**TOWN OF ERIE
BOARD OF TRUSTEES
April 23, 2019**

SUBJECT: Spring Hill Sketch Plan - A Sketch Plan represents a generalized land use plan and layout for the area proposed to be included within a subdivision. A Sketch Plan application is required to allow for an early, informal evaluation of a proposed subdivision before detailed planning and engineering work has occurred.

PURPOSE: Review and comment on a Sketch Plan application for of 632 lots and 33 tracts as well as right of way, parks, and open space.

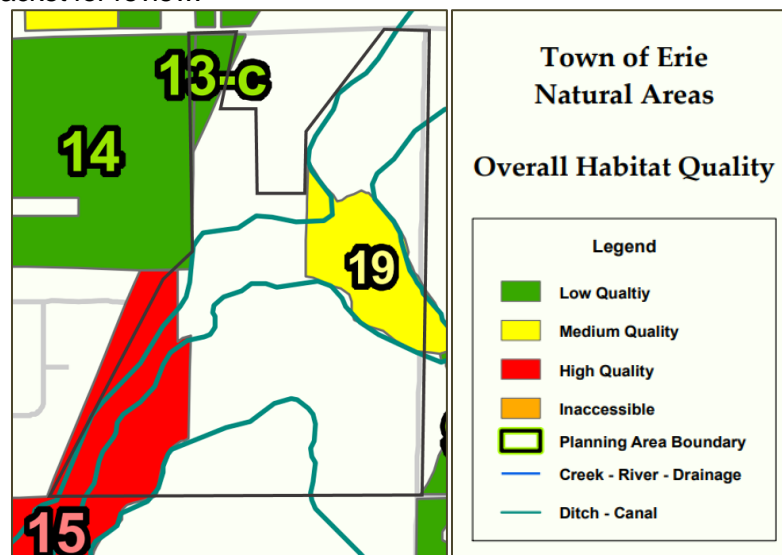
The proposed plan does not align with the Comprehensive Plan Land Use designation for this property. The approximately 70 acre area south and west of the Cottonwood Extension ditch is shown as Agriculture on the Comprehensive Plan. According to the Comprehensive Plan farming, ranching, and other agriculturally related uses and very low density rural residential uses are appropriate in this area. Also, lands designated Agriculture “serve a vital role in defining the history and character of Erie and should be maintained where viable, to serve as gateways and buffers, preserve vistas, and retain the desired character of the Town.” Within this area the sketch plan shows the western edge, the areas adjacent to the western two ditches (Lower Boulder Ditch and the Boulder/Weld Ditch), as open space and develops the remainder at a density consistent with an LDR land use designation. The LR Zone Designation (which defines allowed uses and development standards for those uses) does not negate the need for the subdivision plan to be consistent with the Comprehensive Plan. A Comprehensive Plan amendment allowing the change in Land Use designation from this area would be required to be approved for this subdivision plan to conform to the Comprehensive Plan.

The Land Use Plan Map identifies, with a green flag, a future Saint Vrain Valley School District school site on the property. The sketch plan anticipates and provides a 10 acre elementary school site.

Overall Sketch Plan

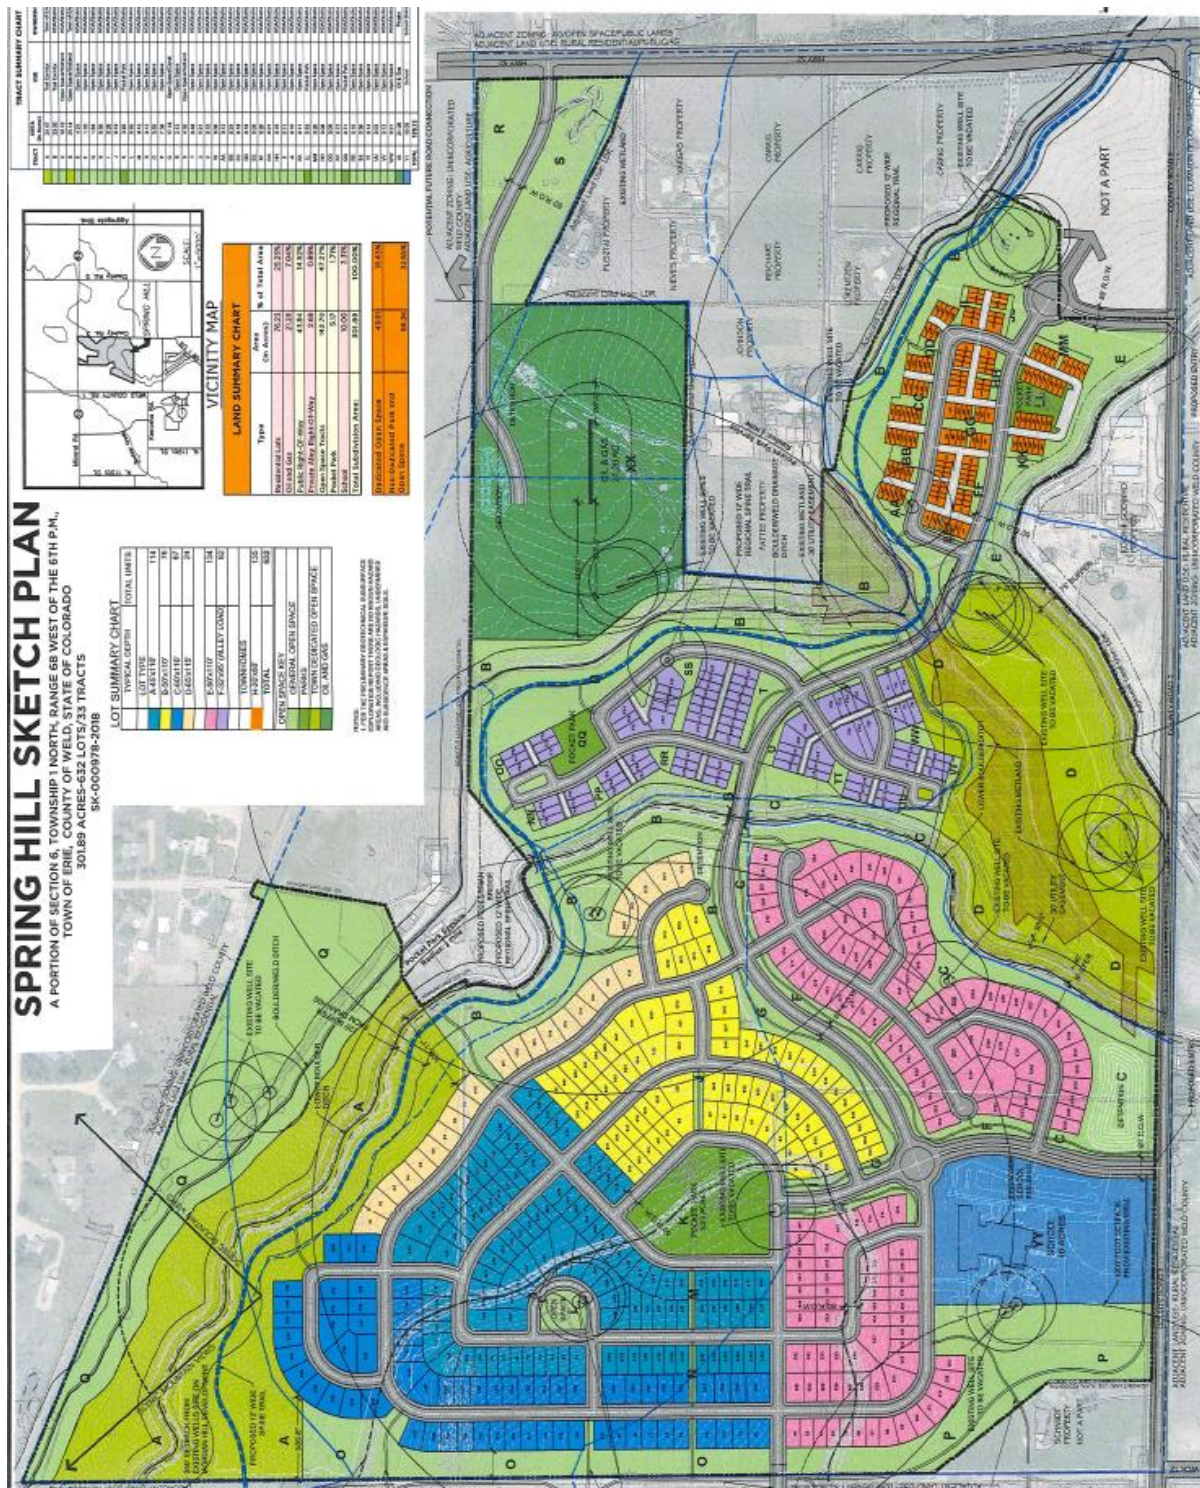
The UDC section on the Preservation Of Existing Main Ditches states “existing irrigation ditches shall be incorporated into subdivision plats and preserved as open space areas to the maximum extent reasonably practicable”. The Cottonwood Extension Ditch (the ditch highest on the hill) enters the property from the south where it exits Morgan Hill and extends to the north and east before it turns south east to exit the property where it reenters the Morgan Hill development. The Cottonwood Extension Ditch, when examined during the review for the adjacent Morgan Hill, was found eligible for the National Register of Historic Places and coordination with the State Historic Preservation Office was required for the portion of the ditch which will be put underground as part of that project. The Sketch Plan proposes to underground the length of the Cottonwood Extension Ditch throughout the development.

Within the subject property the proposed Sketch Plan anticipates the closure of the existing oil and gas wells and associated facilities. These operations are proposed to be relocated to a 21.26 acre area in the northwest portion of the property where a separate access point into Highway 52 would be developed.

Other oil and gas operations exist to the south of the project within the Morgan Hill development. The Sketch Plan shows a 1,000 foot setback from the wells located south of the school site and a 350 foot setback from the wells on the west side of Morgan Hill.
